Sag Harbor

Suite #418

INVENTORY SUITE

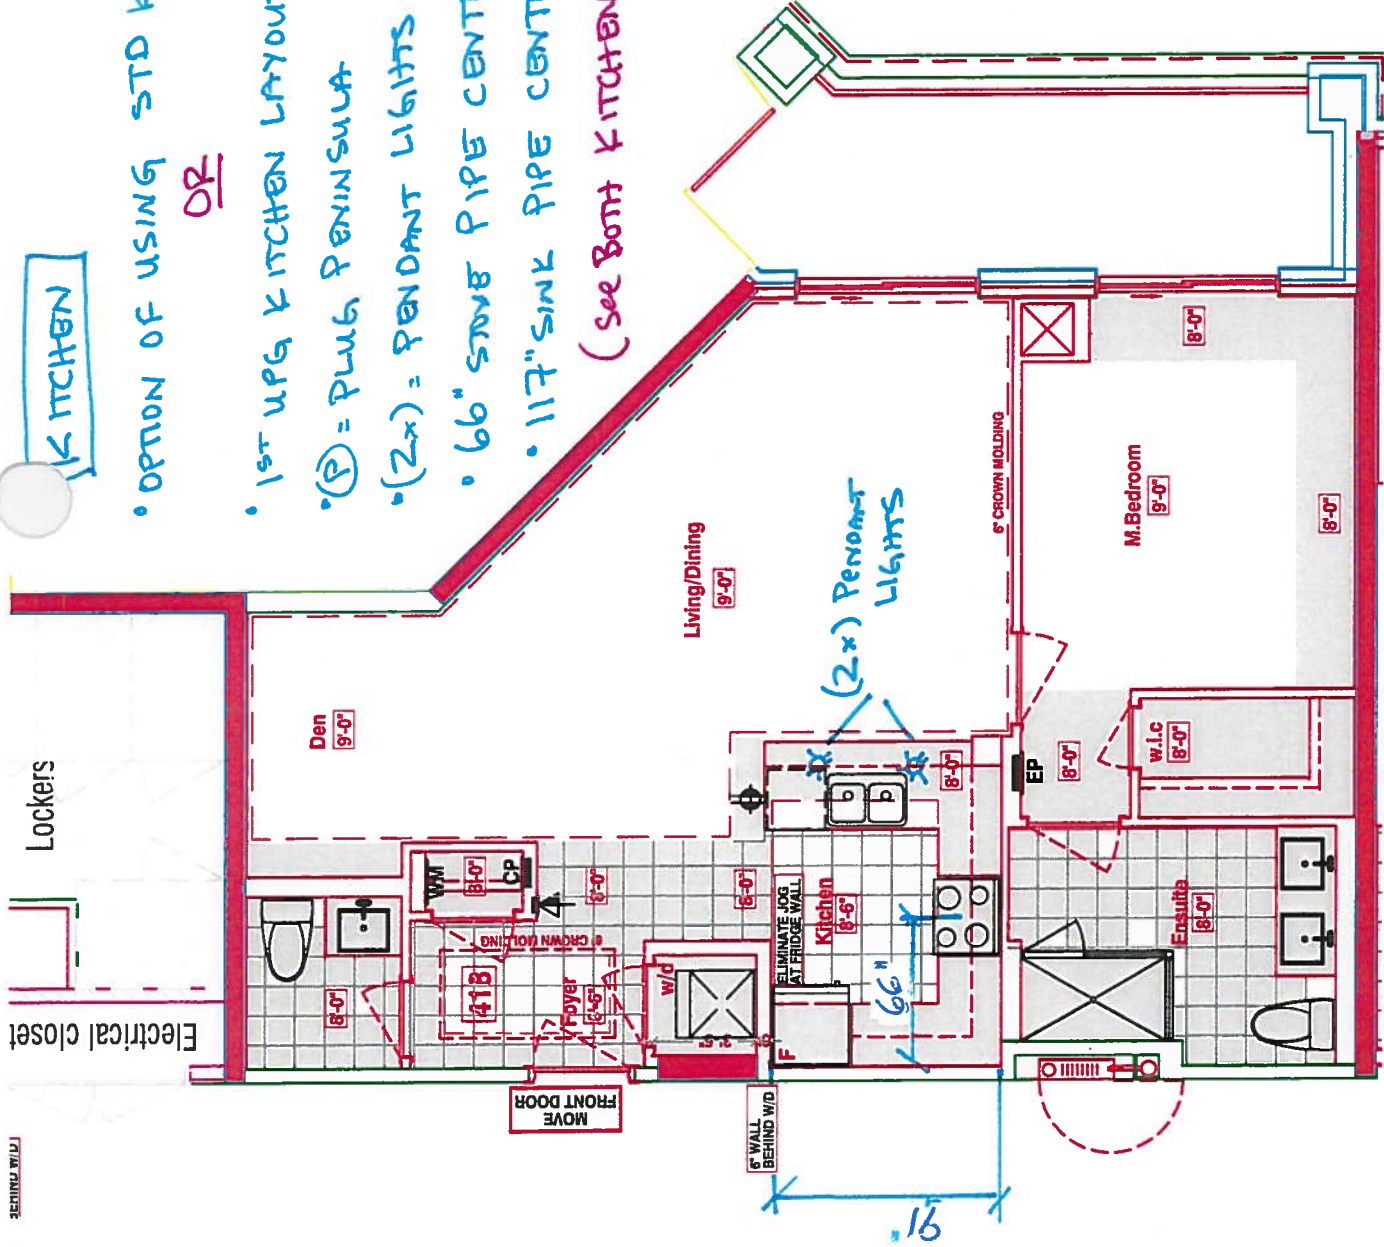
* MOVE FRONT DOOR
DUE TO 6" WALL
BEHIND WASHT/ DRYER

- OPTION OF USING STD KITCHEN LAYOUT w/ STD APPLIANCE PACKAGE
 - 1ST UPG KITCHEN LAYOUT w/ 1ST UPG APPLIANCE PACKAGE
 - (P) = PLUG PENINSULA
 - (2x) = PENDANT LIGHTS OVER PENINSULA
 - 66" STOVE PIPE CENTER
 - 117" SINK PIPE CENTER
- (SEE BOTH KITCHEN LAYOUT OPTIONS)
